PUBLIC NOTICE - APPROVAL OF REVISED WEST DRAINAGE CHANNEL MASTER PLAN, SUNSHINE CANYON CITY/COUNTY LANDFILL, SYLMAR, CALIFORNIA (FILE NO. 58-076, ORDER NO. R4-2008-0088, GEOTRACKER GLOBAL ID NO. L10006014618)

APPROVAL OF REVISED WEST DRAINAGE CHANNEL MASTER PLAN - SUNSHINE CANYON LANDFILL, SYLMAR, CALIFORNIA (FILE NO. 58-076, ORDER NO. R4-2008-0088, GEOTRACKER GLOBAL ID NO. L10006014618)

COMMENTS ON WEST DRAINAGE CHANNEL MASTER PLAN - SUNSHINE CANYON LANDFILL, SYLMAR, CALIFORNIA (FILE NO. 58-076, ORDER NO. R4-2008-0088, WQID NO. 4B190329001)

**WEST DRAINAGE CHANNEL MASTER PLAN
SURFACE WATER DRAINAGE ANALYSIS REPORT
SUNSHINE CANYON CITY/COUNTY LANDFILL**

REVISION _____ _____ _____			SUNSHINE CANYON LANDFILL	FIGURE 1
			WESTERN DRAINAGE MASTER PLAN	PROJECT NO. 0014-0004
			SYLMAR, CALIFORNIA DRAINAGE MAP	ISSUED FOR REVIEW

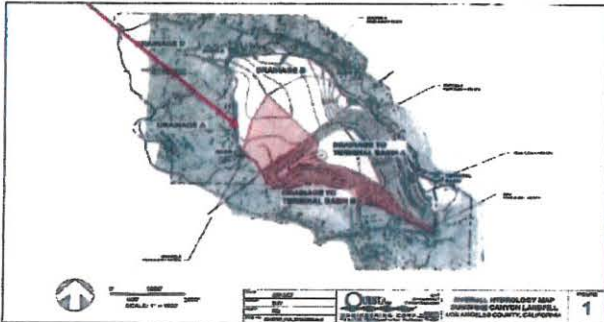
- The Drainage Map, Figure 1, provided under Attachment D shall include adequate topography, clarity, and resolution to depict watershed delineation. Each subarea shall be clearly labeled, and subarea collection points shall be shown. The Time of Concentration path from the most remote point of the subarea to the outlet of the subarea shall also be clearly identified. Elevations at the top and at the outlet point of each subarea shall be shown. The paths through which surface flows from the subareas are conveyed to the proposed West Drainage Channel shall also be shown. All drawings including any details, as well as any attachments must be clearly legible in order to facilitate proper review.

- The current hydrologic analysis for the West Drainage Channel is not based on the topography at the point of the landfill's built-out condition. At build-out a substantial area, shown as the area highlighted in red on the enclosed Drainage Map, will become tributary to the West Drainage Channel. Also, not included in the hydrologic analysis is the contribution from the immediate area south of the trapezoidal channel shown as the area highlighted in yellow on the enclosed Drainage Map. Both of these areas shall be included in the hydrologic analysis.

JTD Map of Built Out Condition, portion of watershed tributary to Western Drainage Channel is highlighted in red
